APPLICATION NO.	FILING DATE	FIRST NAMED INVENTOR	ATTORNEY DOCKET NO.	CONFIRMATION NO.
10/590,587	10/25/2006	Hideki Watanabe	S004-5852 (PCT)	8549
<div>7590 Bruce L Adams Adams & Wilks 17 Battery Place-Suite 1231 New York, NY 10004</div>			<div>EXAMINER COLILLA, DANIEL JAMES</div>	
			<div>ART UNIT 2854</div>	<div>PAPER NUMBER</div>
			<div>MAIL DATE 11/30/2009</div>	<div>DELIVERY MODE PAPER</div>

Office Action Summary	Application No. 10/590,587	Applicant(s) WATANABE ET AL.	
	Examiner Daniel J. Colilla	Art Unit 2854

DETAILED ACTION

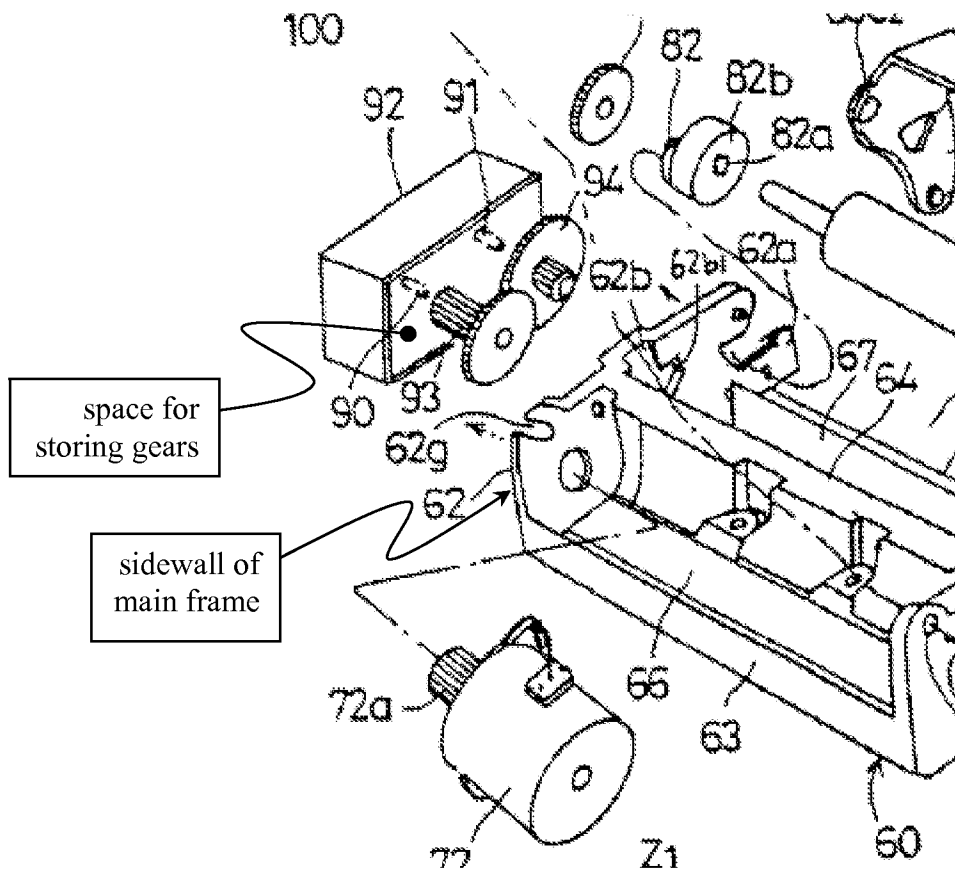
Additionally, Mori *et al.* discloses a drive gear 72a of the motor and the idler gears 93, 94 are stored in a space defined by the gear fitting member; and one of the side walls of the main frame as shown below in the Fig. taken from Fig. 4 of Mori *et al.*
